# DEVELOPMENT REVIEW COMMITTEE (DRC) COMMENT REPORT

**PROJECT NAME:** Claridge Oakland Park

**CASE NUMBER:** PLN-SITE-20070002

**REQUEST:** Site Plan Level III Review: Conditional Use for Waterway Use, Mixed Use Development with Allocation of 108 Residential Flex Units and 4,000 Square-Feet of Retail Use

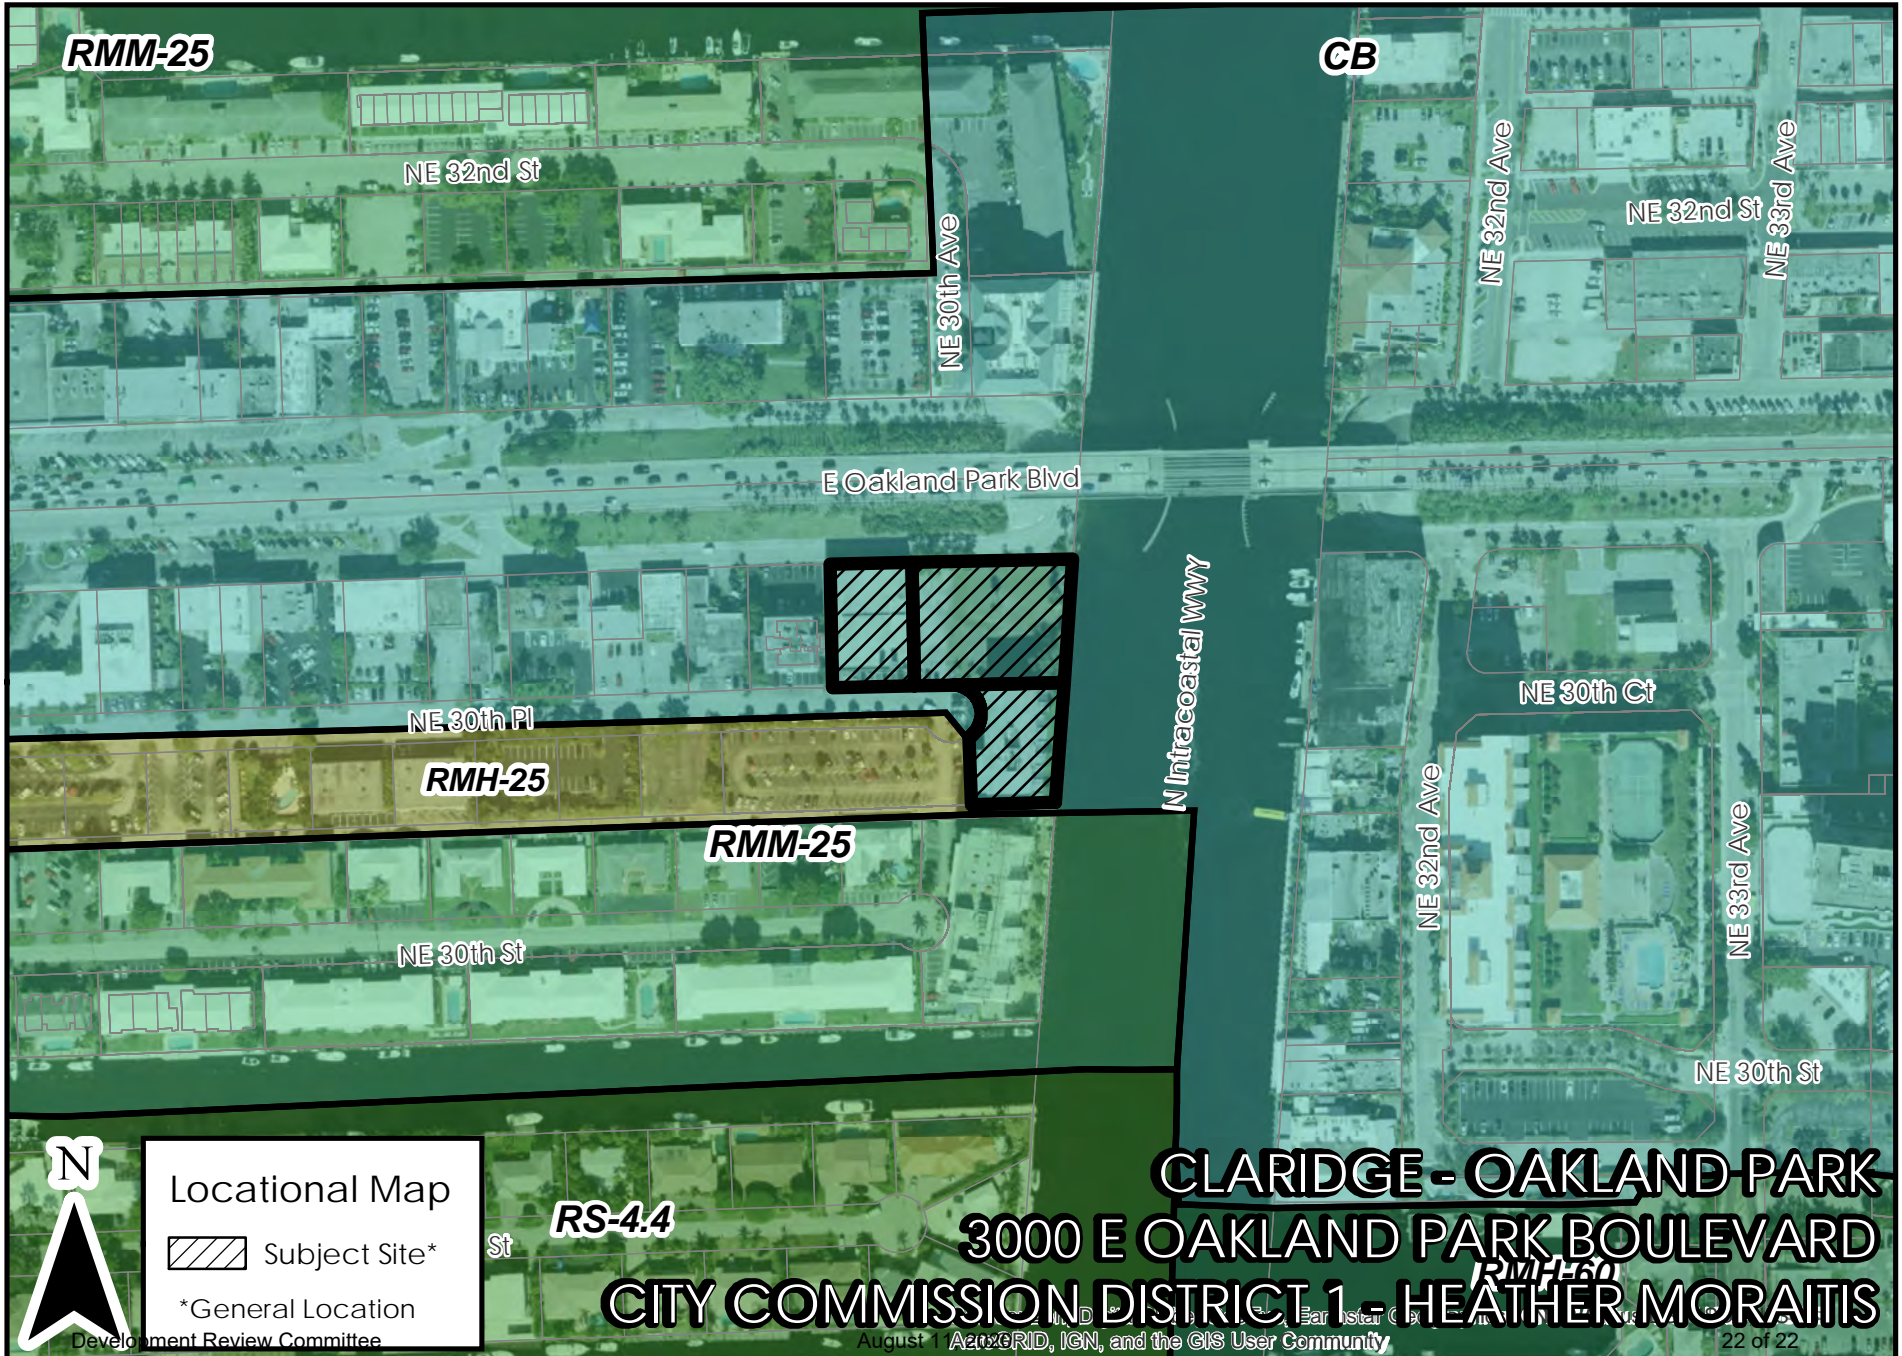
24. Provide a photometric plan for the entire site. Extend values on photometric plans to all property lines. Show values pursuant to ULDR, Section 47-25.3.A.3.a and 47-20.14. Indicate lighting poles on site plan and landscape plan and provide detail with dimensions. Garage internal lighting fixtures and glare cannot be visible from neighboring properties.

Indicate lighting poles on site plan and landscape plan and provide detail with dimensions. Be aware that lighting fixtures greater than ten (10) feet in height are used, they shall be located a minimum of fifteen (15) feet away from shade trees (Section 47-20.14). Provide total height of light pole on sheets.
